Design Advisory Board

Tuesday, May 27, 2025, 3:00 PM

To: Design Advisory Board
From: Garret King
Re: 57 Intervale Avenue
Date: May 27, 2025

To: The Design Advisory Board
From: Mary O'Neil, AICP, Principal Planner
RE: ZP-25-170
Location: 196 South Willard Street
Date: May 27, 2025

SHEET NAME
SITE PLAN

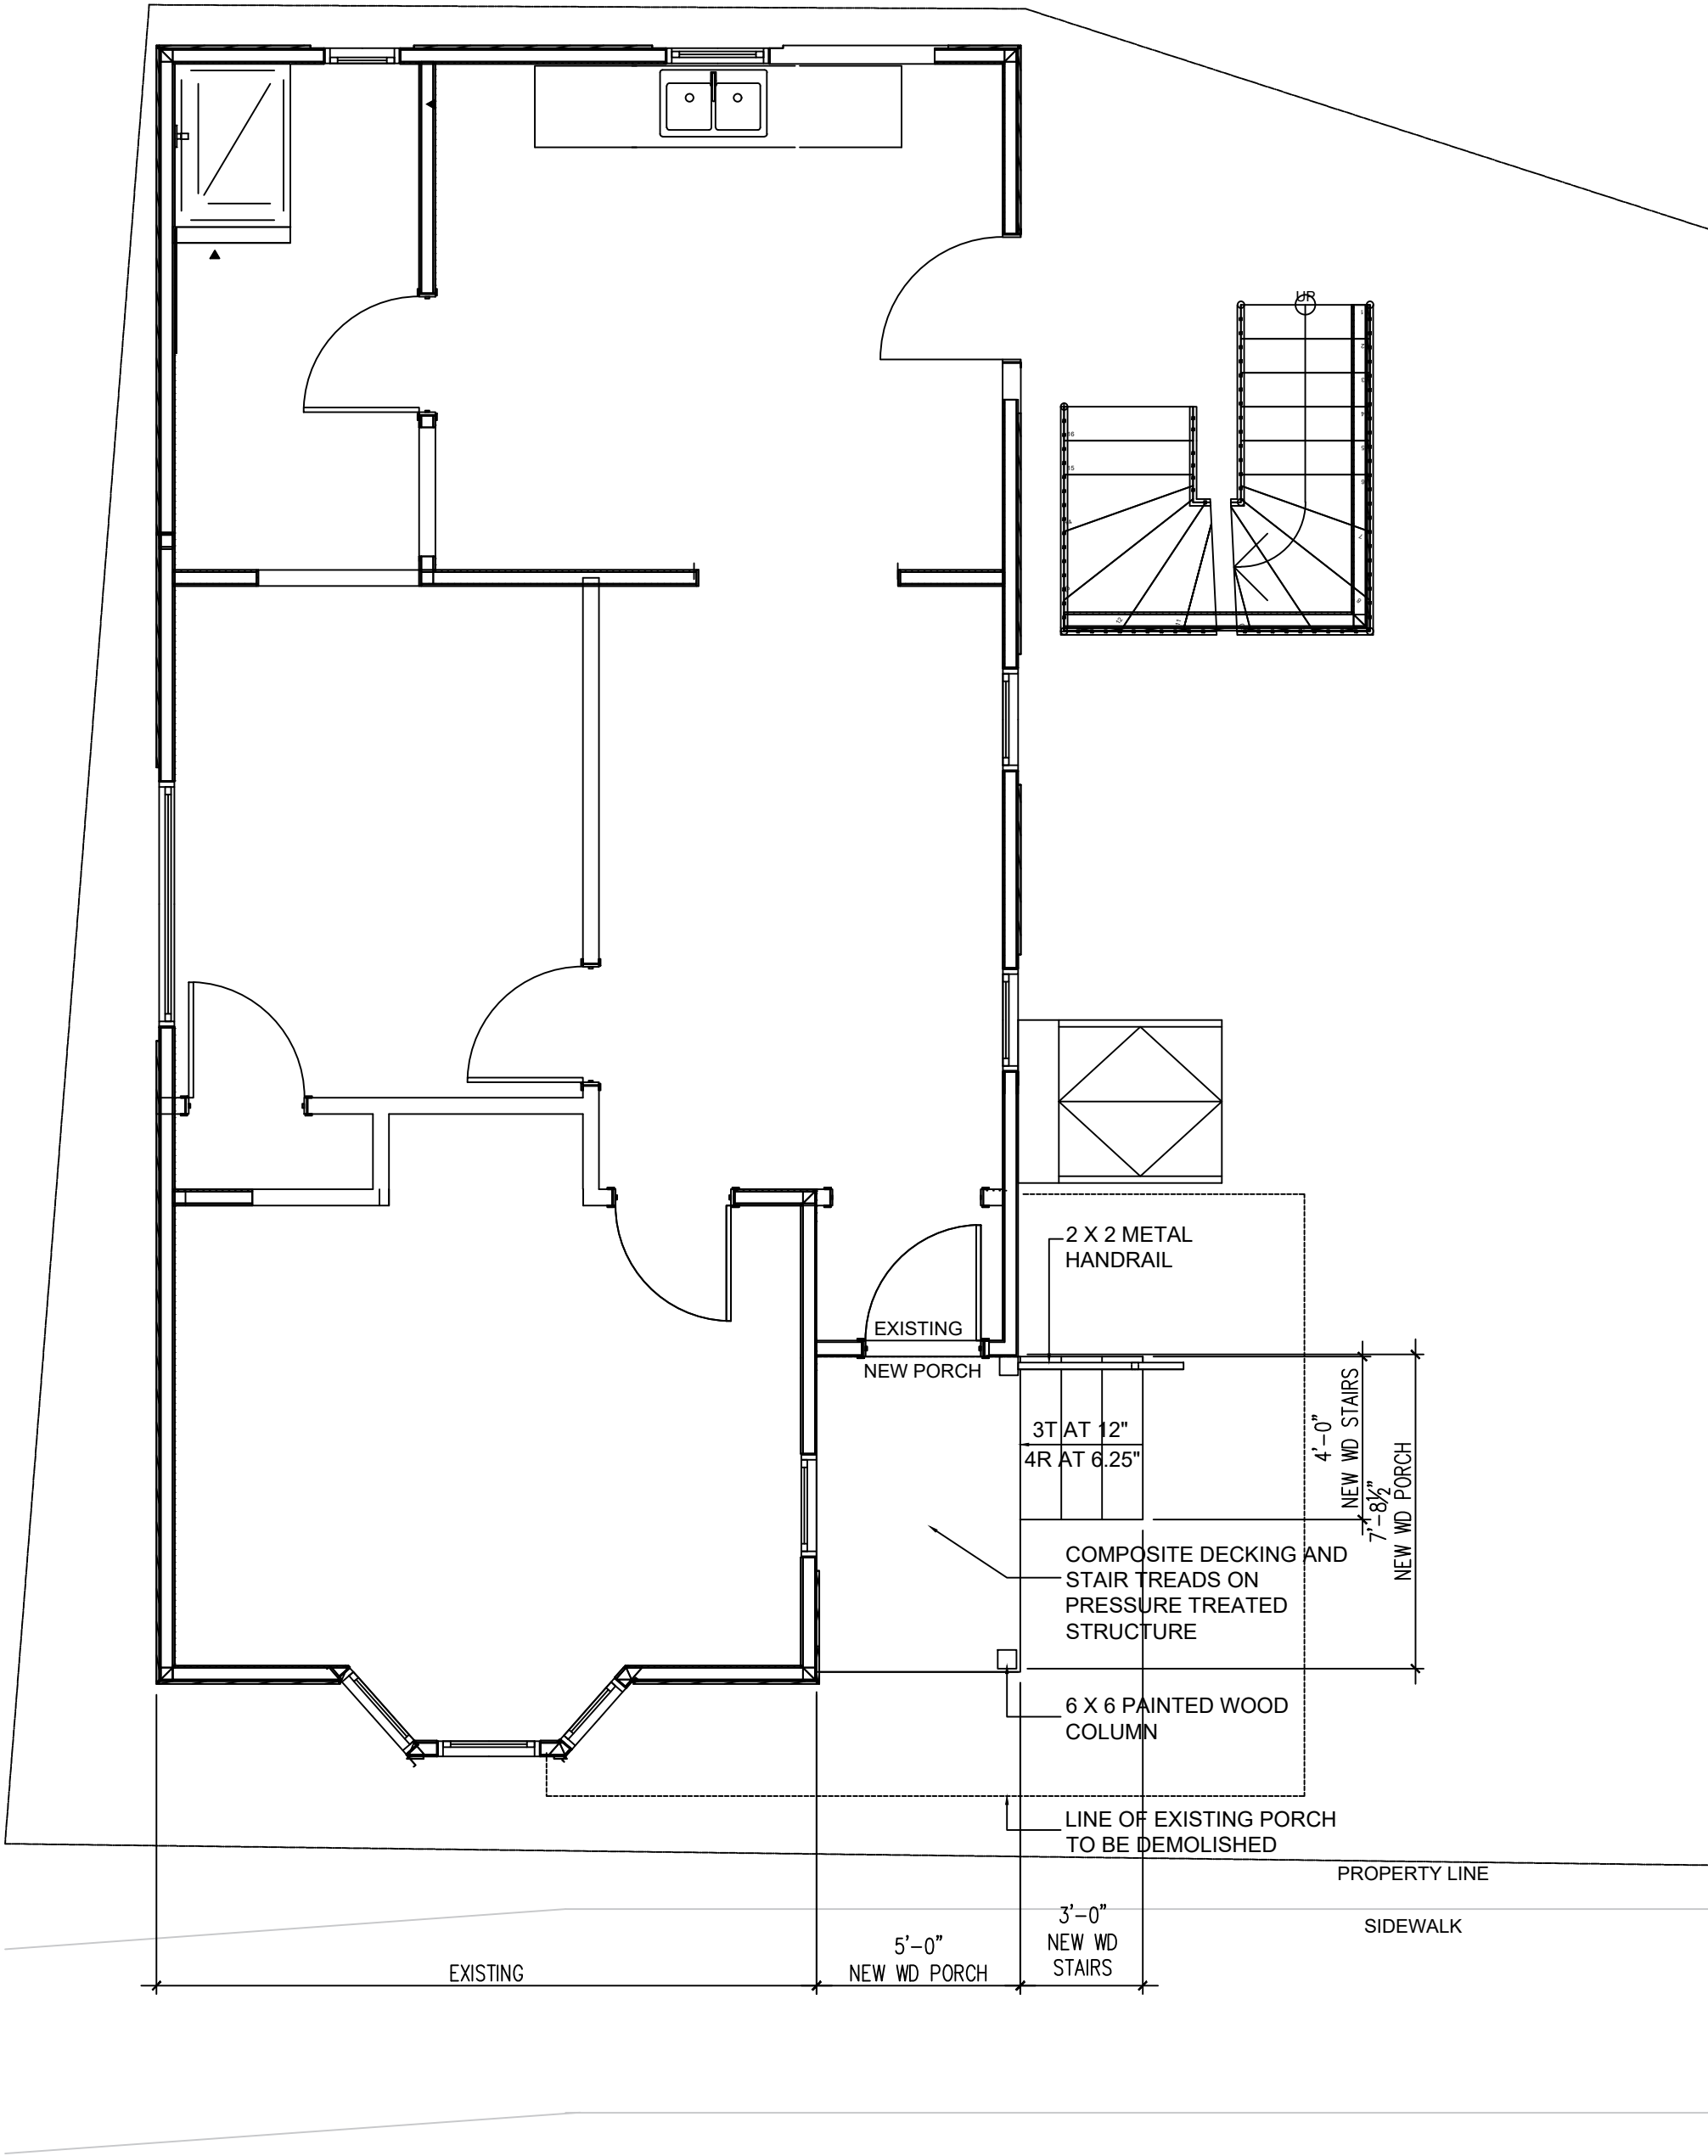
The proposal will have the stairs from the porch lead onto the yard. No pathway is proposed to connect the entrance to the sidewalk and should be required.

MATERIALS AND LAYOUT PLAN

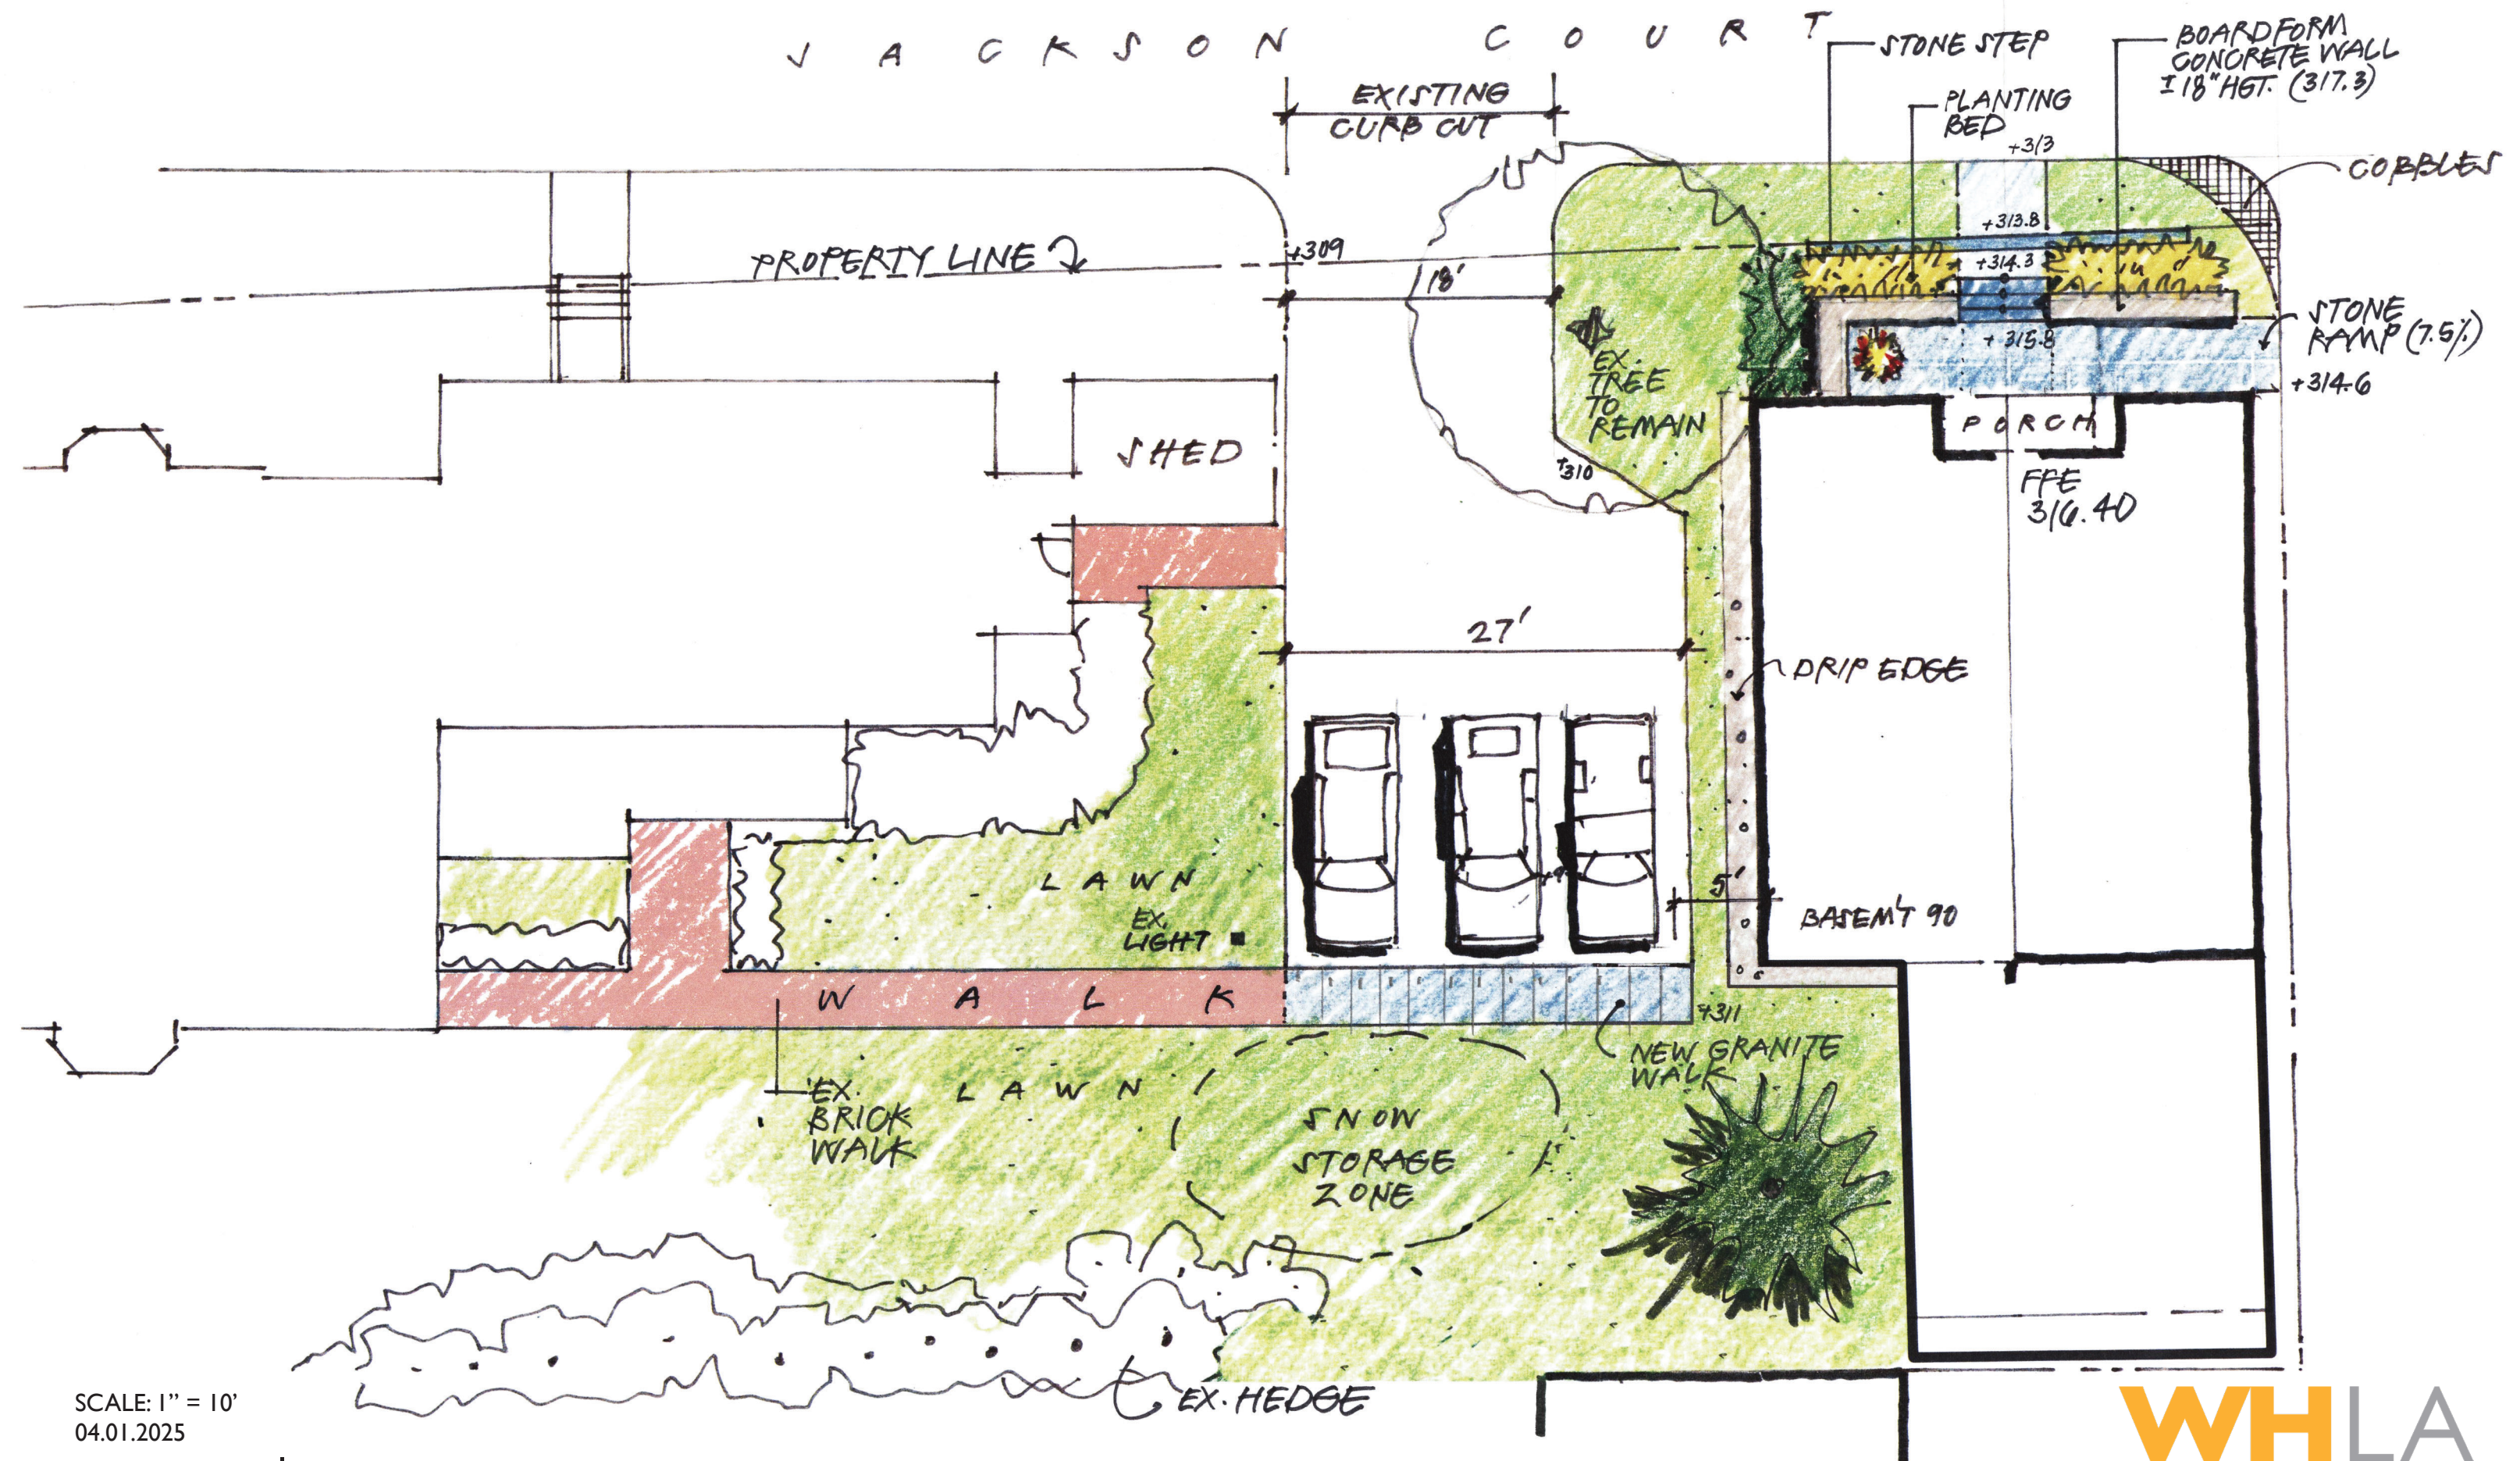
There is an existing curb cut, which is proposed to be retained. A parking area is proposed to be enlarged to accommodate 3 cars. The applicant has been reminded that lot coverage is limited to the previously approved 49% (which is non-conforming for the zoning district), so site plan revisions may be necessary to reduce the expanded lot coverage illustrated on the Wagner/Hodgson plan.

There are no public sidewalks on Jackson Court, where the street is very narrow. A previously approved site plan showed access directly from the parking area; however this plan “breaks” that connection, and orients pedestrian access directly from Jackson Court. The site plan additionally proposes a stone access ramp from the easterly-abutting property to this building entrance, which will require entering neighboring private property. If retained, an easement for that access may be warranted.

This parking plan (Wagner Hodgson) appears to increase the amount of lot coverage and may have to be minimized. The parking arrangement will require vehicles to back out onto Jackson Court, but that is an existing condition. Parking is laid out at the side (or rear) of existing structures. The granite walk may not be sufficient to keep vehicles from parking on green space.

An existing tree adjacent to the carriage barn will be retained. The landscaping plan includes the addition of a stone ramp accessed from a neighboring property. As the access proposed is outside the parameters of this parcel, an access easement is warranted.

A south boundary line is not illustrated on the landscape plan. After review of a prior approved site plan, it appears that the snow storage zone may be south of this parcel's boundary line. The applicant team shall define.

1. If more than 400 sq. ft. of earth will be disturbed (parking area enlargement), an Erosion Prevention and Sediment Control Plan will be required.
2. Lot coverage is limited to the previously approved 49%.
